**Proposed Text for Section 4 thru 4.1.2.2,
Based on responses to Draft D1 Letter Ballot processed
at March 1995 Meeting**

Abstract: This paper presents the changes to section 4. thru 4.1.2.2 in the Draft Standard P802.11/D1 as a result of the Response to Draft D1 Letter Ballot processed at the March 1995 Meeting as shown in the companion Documents P802.11-95/65 and P802.11-95/66. Not all Letter Ballot comments were processed at the March 1995 Meeting.

Action: Adopt the changes in this paper to replace the relevant portions of Section 4 of P802.11/D1.

Figure 4-1: MAC Frame Format

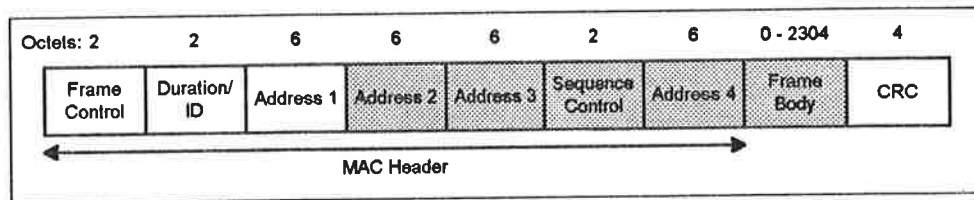
The MAC frame format comprises a set of fields that shall occur in a fixed order in all frames. ~~Some fields may be absent from some frame types.~~

Figure 4-1 depicts the general MAC frame format and field order. ~~The fields that appear shaded are only present in certain frame types. Each field is defined in section 4.1.2. The format of the each of the individual frame types is defined in section 4.2. The format of the MAC header for each of the frame types is defined subsequently. Subsequent sections define each of the fields of the MAC header.~~

A frame is an ordered octet string. The order of transmission of the octets of a frame shall be from left to right.

Figure 4-2: Frame Control Field

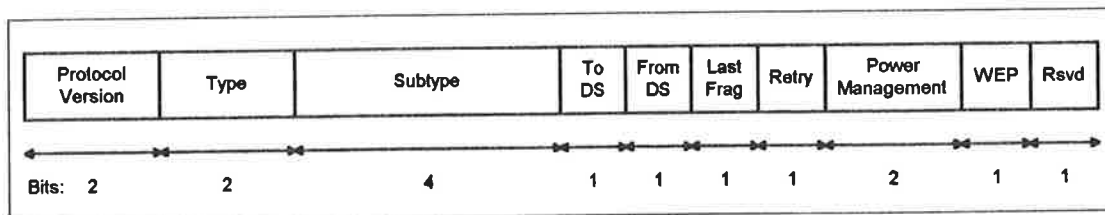
The Frame Control field shall consist of the following sub-fields: Protocol Version, Type, Subtype, To DS, From DS, Last Fragment, Retry, Power Management and WEP Elements Present. The remaining subfields in the Frame Control field are reserved. All reserved bits and fields shall be set to '0'. Reserved bits and fields shall be ignored on reception.
